Consultee Feedback

RBC Natural Environment - Objection

Proposal: Proposed new MRI unit in a temporary modular building, for a period of 5 years

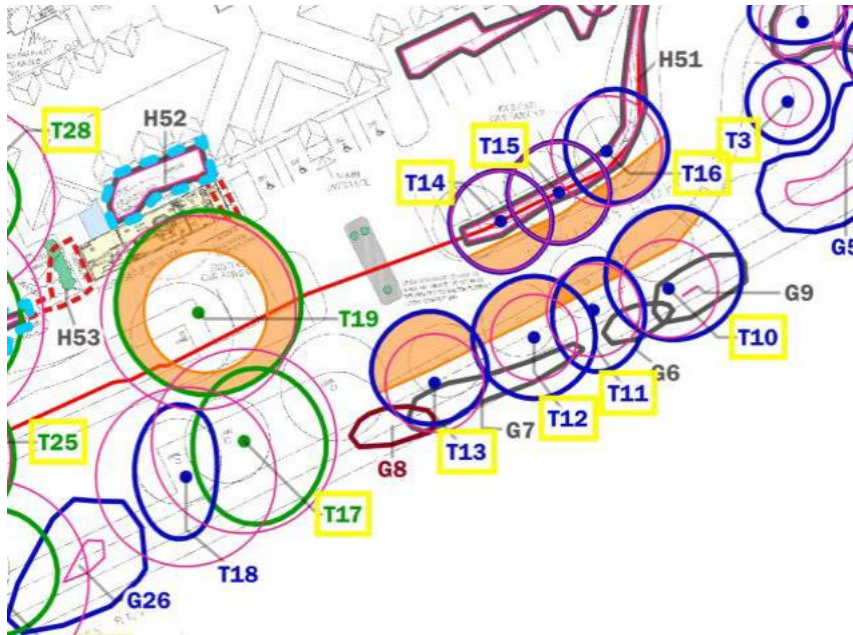
diagram of this is requirement is provided within the Crane Working Area diagram (Appendix EDP 10) and will necessitate the crown reduction of T10, T11, T12, T13, T14 and T15 to achieve this clearance. The setting down of the unit will require the selective pruning of T19; this will be to the branches adjacent to the final location of the unit to allow for the required clearance.' The specifications for the canopy reductions are not mentioned in the report. However, they are shown in the Tree Protection Plan, 10th July 2025, Drawing No. edp9335_d002a, as the orange areas below.

T19 is an 'A' category, mature Hybrid Black Poplar tree. The TPP proposes a significant overall canopy reduction. I note that the tree has previously been pruned to form a pollard yet the works required are not described as a 're-pollard'. This would be an acceptable form of maintenance to the tree however clarity on the pruning specification is required.

T10-T16 are six 'B' category, early-mature Lime trees. The TPP proposes significant partial canopy reductions to all of these trees to facilitate the requirements for the crane access. A specific pruning specification has not been provided and no significant defects are recorded. The unclear pruning specification does not give us security or clarity of the true extent of the works. The Natural Environment Team are only supportive of significant canopy reductions where significant defects are present and that the trees structural integrity and stability are questionable. The extent of the canopy reduction

appears to be detrimental to tree health, appearing to be more than one third of the canopy removed which does not follow the BS3998 2010 recommendations. The proposed reductions will leave the trees with an extremely unbalanced canopy structure which is not justified.

I note 8.10 states '*A proposed 4.5m clearance is required within the entrance of the Site*' – it is unclear whether this clearance is needed from ground level or in width across the access path. I encourage that an alternative lesser pruning specification is proposed to meet with the clearance requirements, as the current clearance requirements are unclear and the proposed canopy reductions will have a detrimental impact to tree health. I note in an email sent from W H Bence (Coachworks) Limited it is stated that '*We would need full height clearance in the pick area, so no branches overhang the lift.*' and '*Tree cut back full width road & pavement to min 4.5m clearance*' – this appears to imply a crown lift to 4.5m for the full road width, hence would not necessitate the crown reductions indicated on the TPP. Yet this is not specified in the report and for reasons stated above it is not acceptable to prune the trees in such a way to achieve this. Clarity on the clearance requirements should be sought so that the impact of the crane operations can be fully assessed.
